TECHNICAL SERVICE BULLETIN							
DATE ISSUED	MODEL YEAR(S) AFFECTED	MODEL(S) AFFECTED	TSB #				
11/27/90	ALL	ALL	37				
BRAND		TYPE					
All <input checked="" type="checkbox"/>	American Star <input type="checkbox"/>	Kountry Star <input type="checkbox"/>	Dutch Star <input type="checkbox"/>	All <input type="checkbox"/>	T T <input type="checkbox"/>	F W <input type="checkbox"/>	
NewAire <input type="checkbox"/>	Mountain Aire <input type="checkbox"/>	Kountry Aire <input type="checkbox"/>	London Aire <input type="checkbox"/>	C A <input checked="" type="checkbox"/>	D P <input type="checkbox"/>	D B <input type="checkbox"/>	
<input type="checkbox"/> Air Conditioning & Heating				<input type="checkbox"/> Electrical Components			
<input type="checkbox"/> Appliances & Accessories				<input type="checkbox"/> Exterior Components			
<input type="checkbox"/> Cabinets & Furniture				<input type="checkbox"/> Interior Components

## Oshkosh Chassis Division Service Bulletin

**DATE:** October 25, 1990  
**Bulletin No.:** OCD-16-90  
**Type:** Service Bulletin  
**Model:** M-Line

**SUBJECT:** Fuel Leak at Carburetor

4-V Bottom View (California Model Shown, 49 State Model Similar)

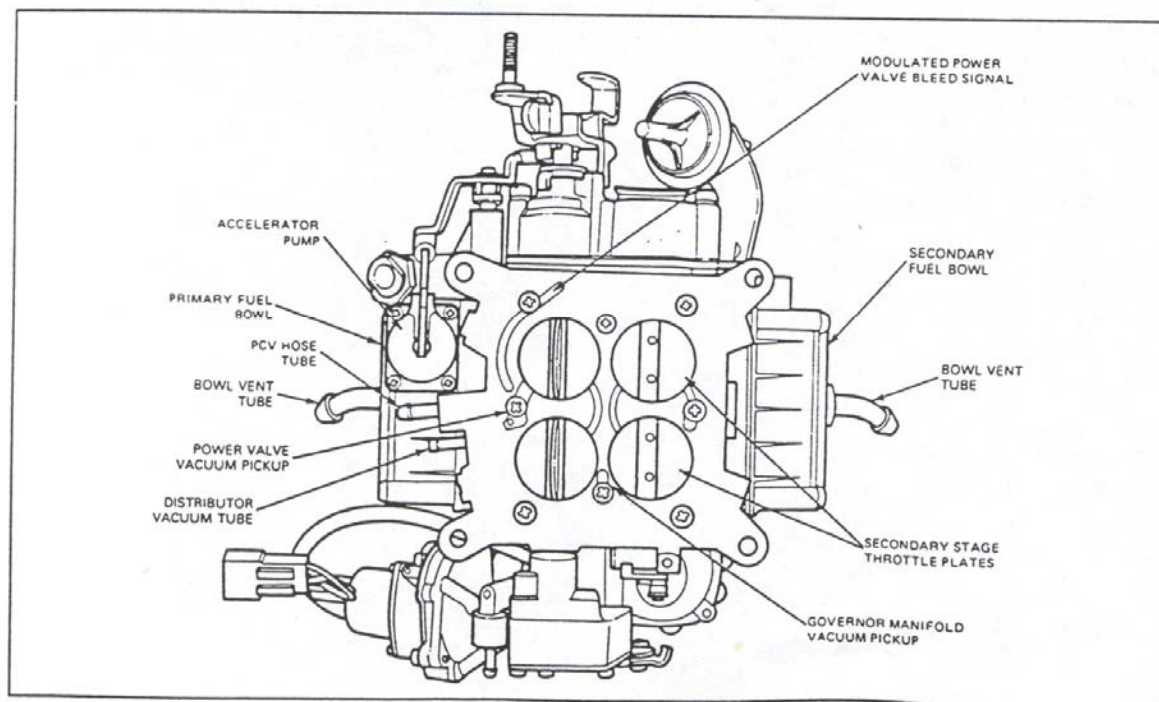
It has come to our attention that some carbureted chassis are experiencing fuel leaks at the carburetor after extensive storage time at the OEM or the retail dealer. This is due to the accelerator pump diaphragm deteriorating during storage.

All carbureted chassis should be checked for possible fuel leaks before they leave the OEM and again before they are delivered to the end user. If any leaks are found, the accelerator pump diaphragm should be replaced using Ford part #FOPZ9B559-A and the charges submitted on an Oshkosh warranty claim.
